Doc or ECO #:	ECO-70809-002	Date:	8/1/2022	Author:	JV
	Rev. #:	001				
Engineering Change Order (ECO)	Engineering Approval:	Aeg	Date:	8/11/2022	Quality Approval	aeg

P/N #:	70809	Effective Date:	August 1, 2022
Title:	Ball-spring set screw retention / receiver adhesion promoter

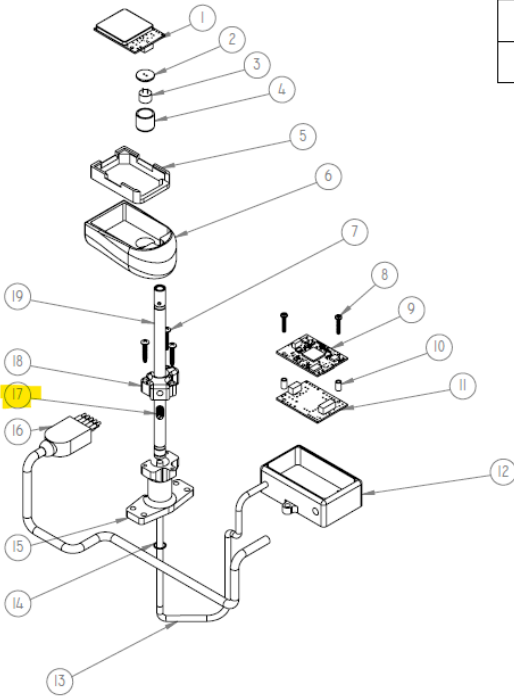
The Ball-spring plunger within the GPS assembly was exchanged with an exact replacement featuring mechanical nylon thread locker. This alleviates the need to apply Permatex blue during production assembly.

Adhesion in the Gps receiver housing has been an issue. Production yields of Gps has been dwindling. An adhesion promoter was added in the BOM and WI.

It was found that Permatex blue was **NOT** entirely curing within PN 72056 (vertical retractability block). This was due to the high chemical resistance of Delrin – the material choice for PN 72056. The new ball spring plunger has a nylon strip that acts as a mechanical threadlocker. Uncured Permatex blue could cause the ball-spring plunger (72057) to become loose over time. This could cause the GPS to have difficulty staying in the “masted” position. Using the new revision of 72057 will help consistency and reliability in future GPS builds.

Gps with new adhesion promoter. Minor cosmetic difference from current production. Note that cosmetics may be worse depending on application of the adhesion promoter
